01/26/2026

**ADDENDUM NO. 3  
TO CONTRACT DOCUMENT PLANS SPECIFICATIONS**

**PROJECT: MWA METRO PARK WEST LANDFILL  
P-67 CELL E LINER, LEACHATE LAGOON, AND SED POND**  
**TO: PROSPECTIVE BIDDERS AND OTHER INTERESTED PARTIES**

SHEET  
**C506**

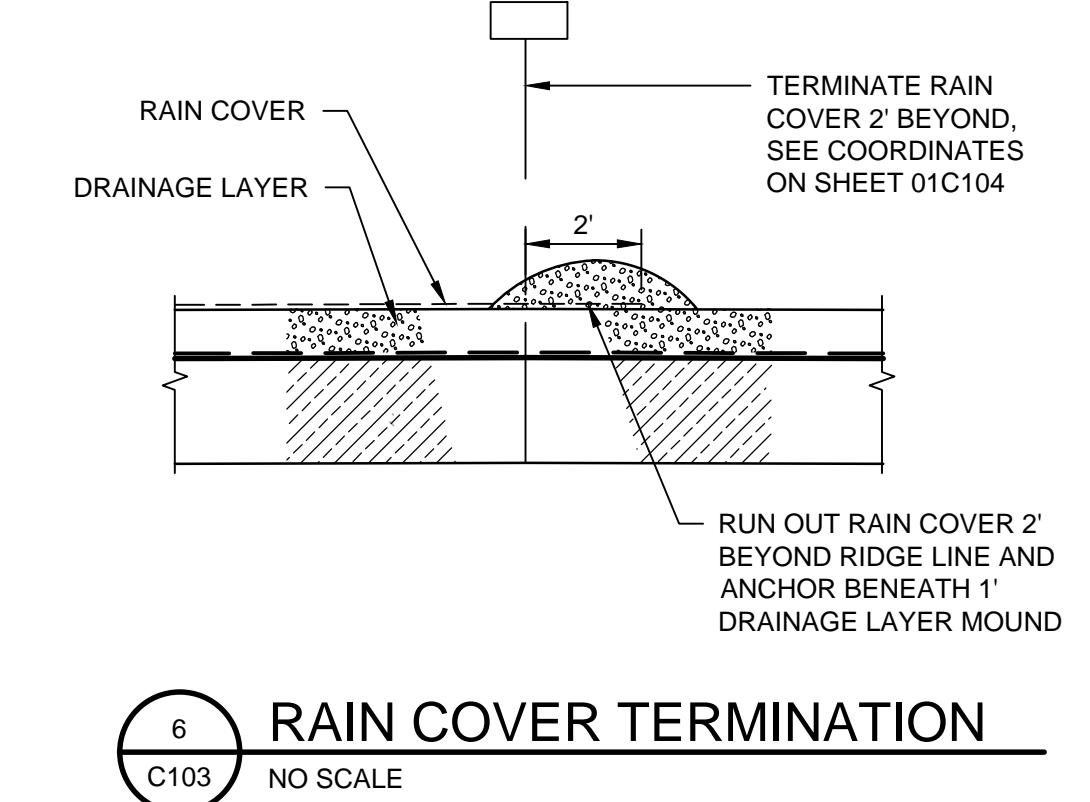
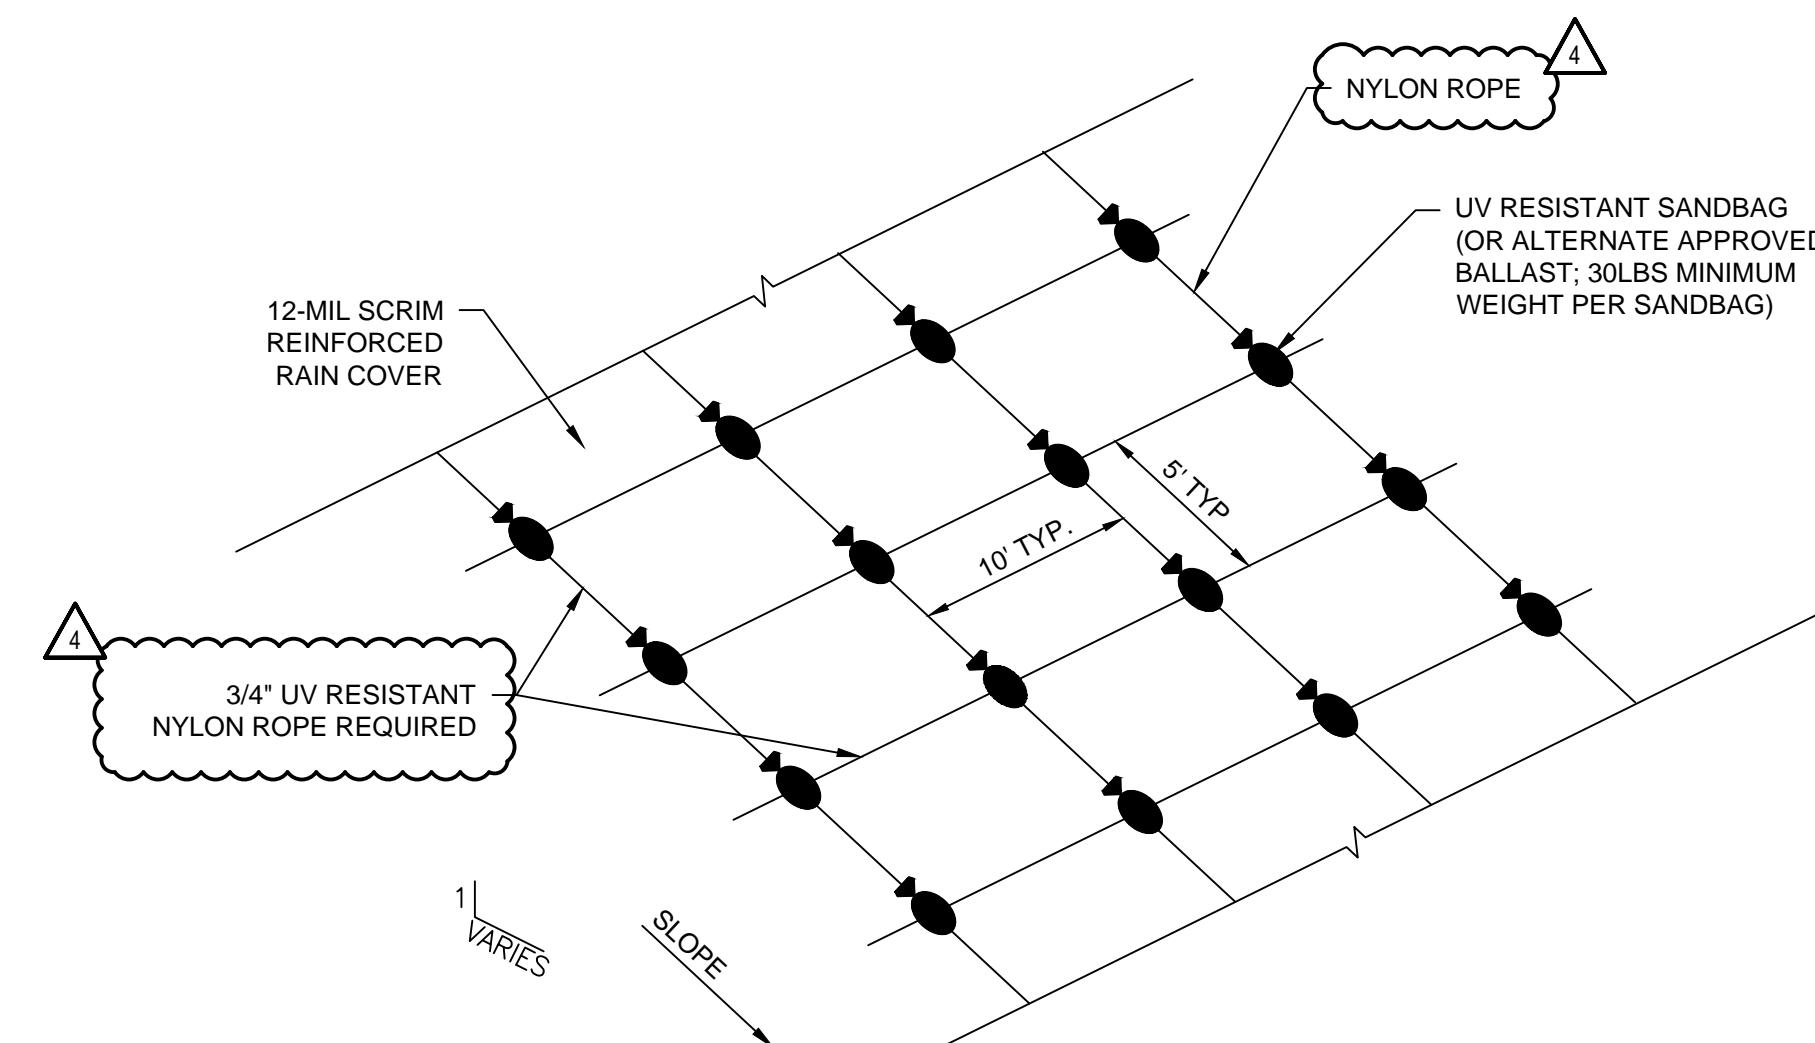
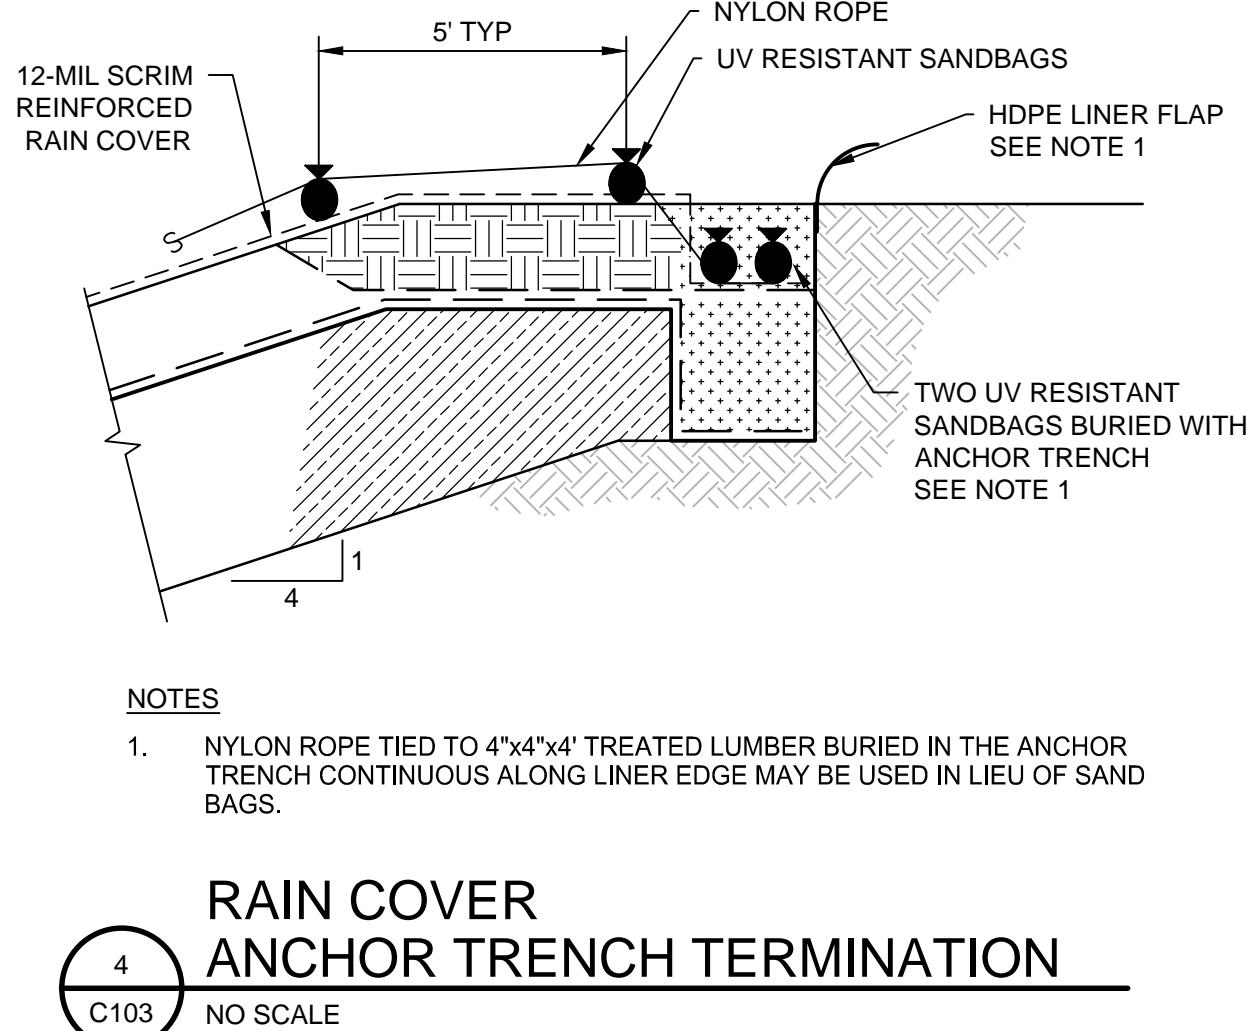
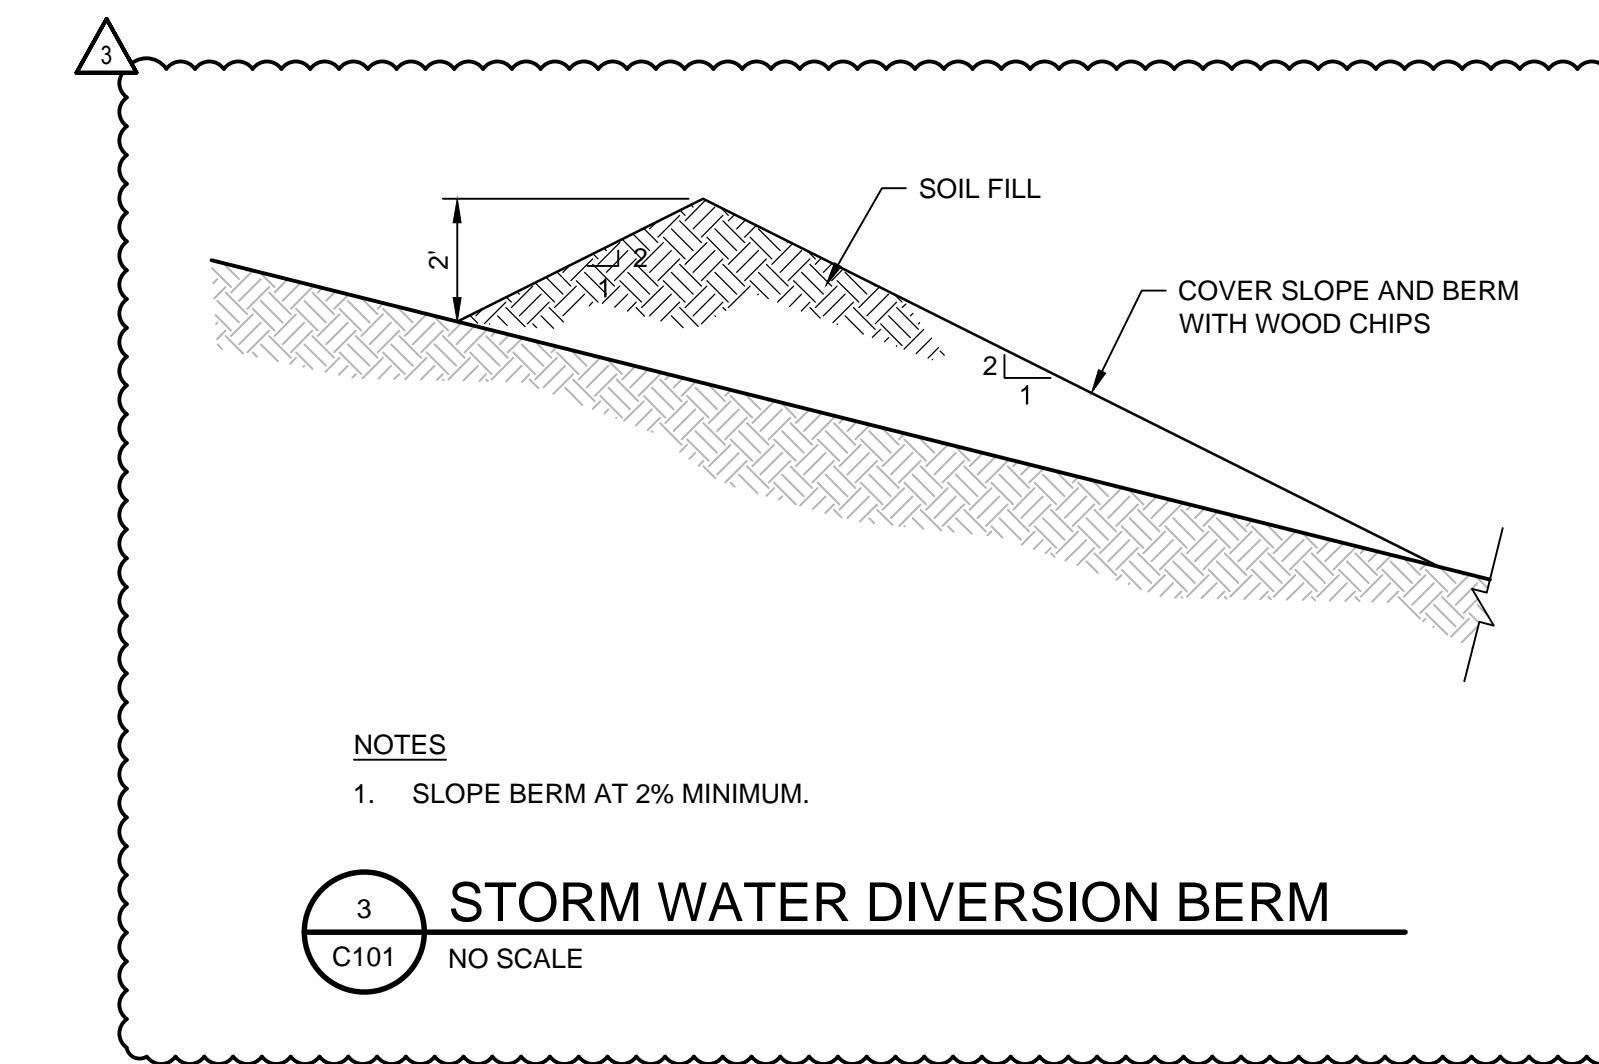
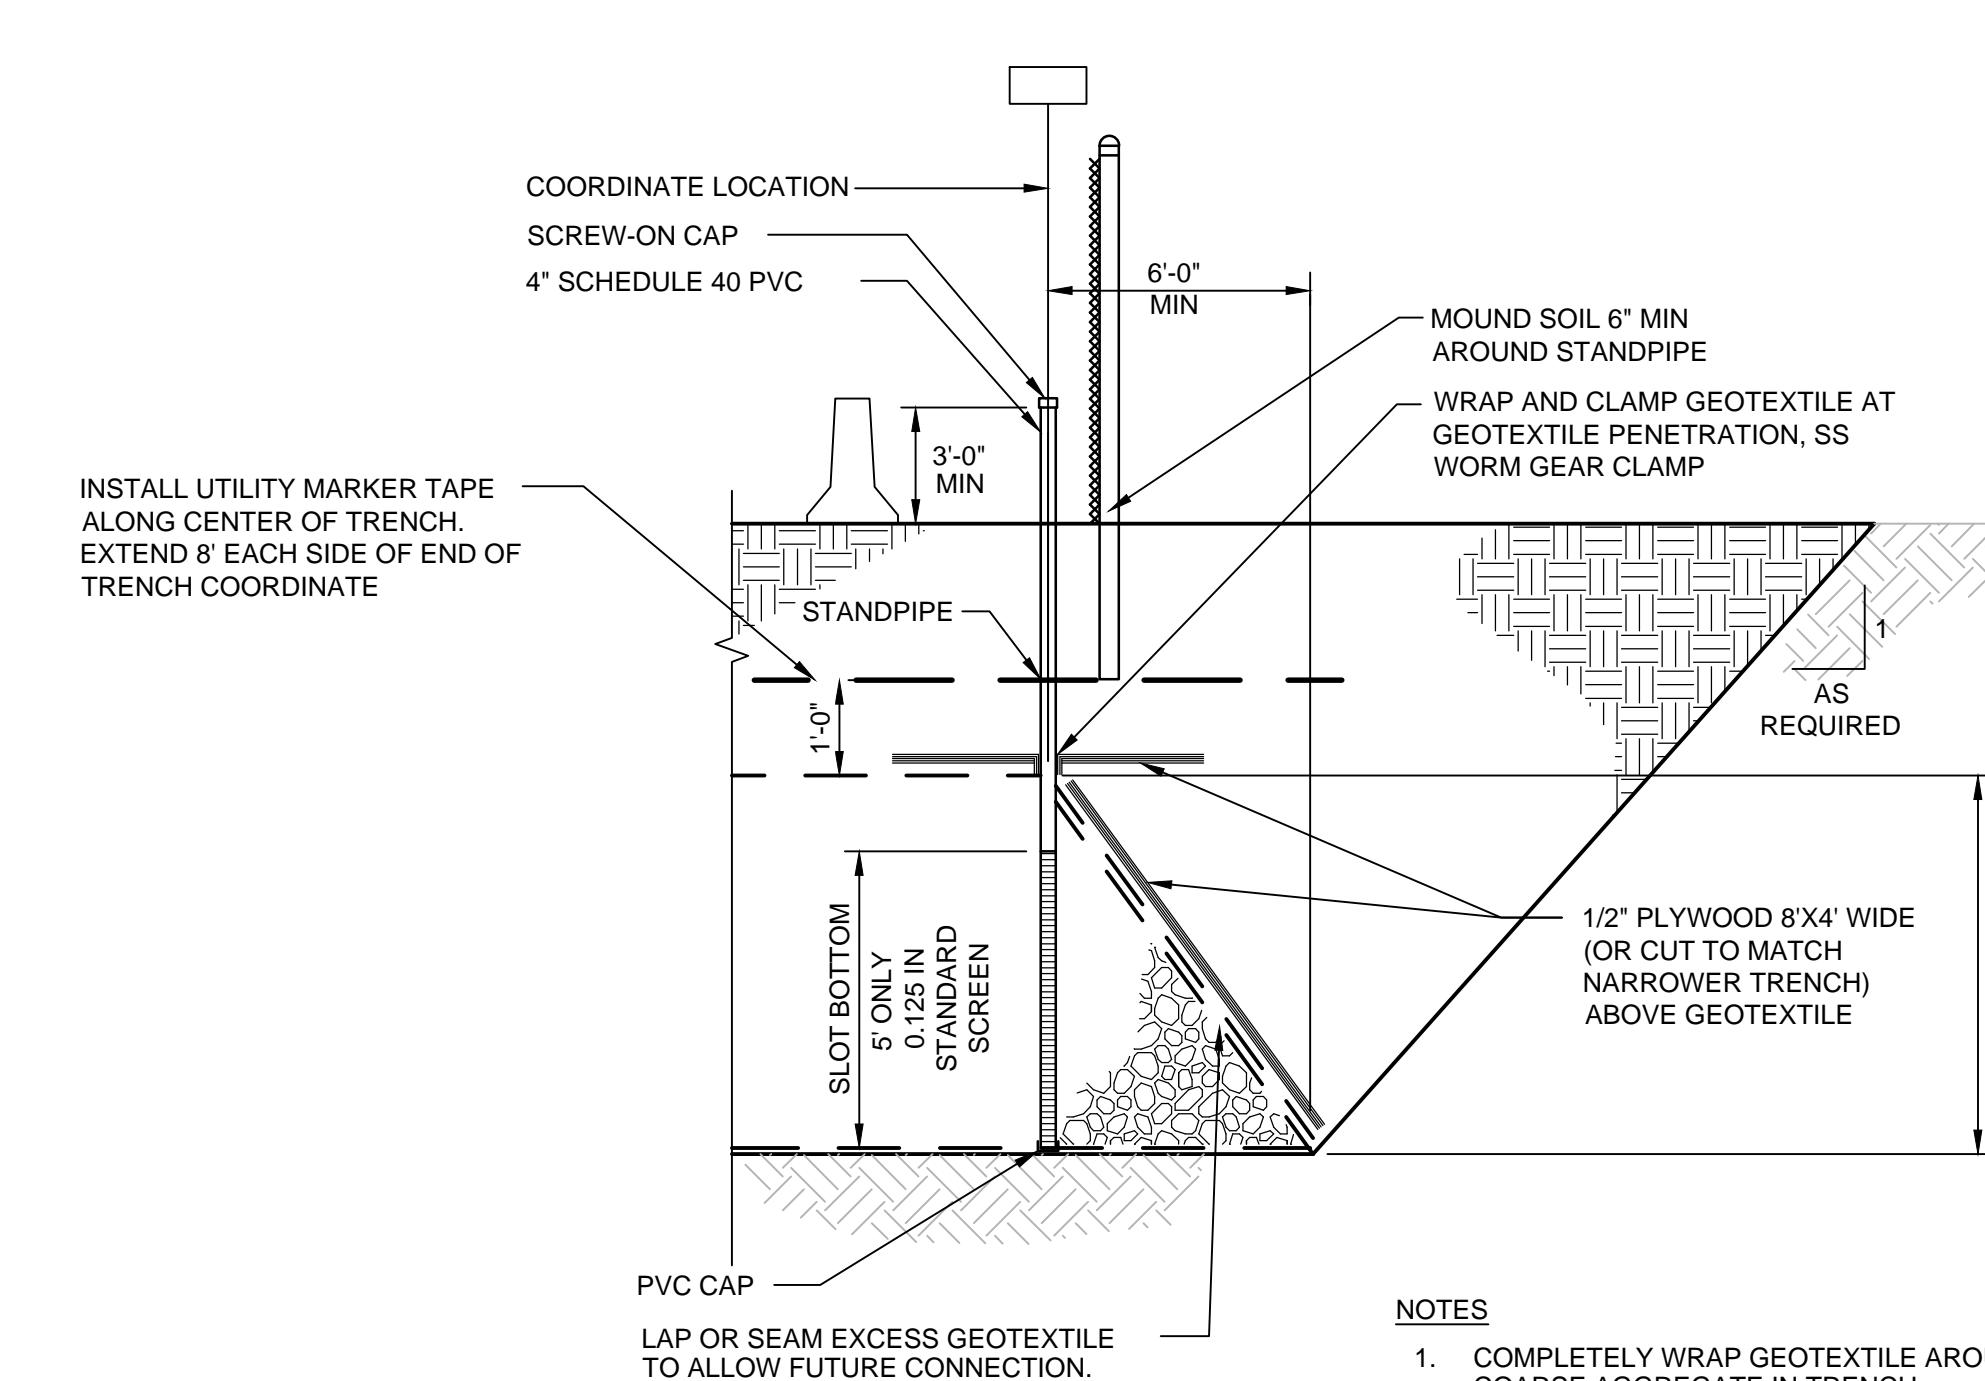
**Question 3:** *Detail 5, sheet C506 outlines nylon rope requirements for sandbag ballast placed on the slopes. Is nylon rope required for bags placed on cell floor to prevent movement of sandbags by adverse weather?*

**Answer 3:** Install  $\frac{3}{4}$ " UV resistant Nylon rope for slopes and floor of Cell E. See revised Detail 5 and on Sheet C506.
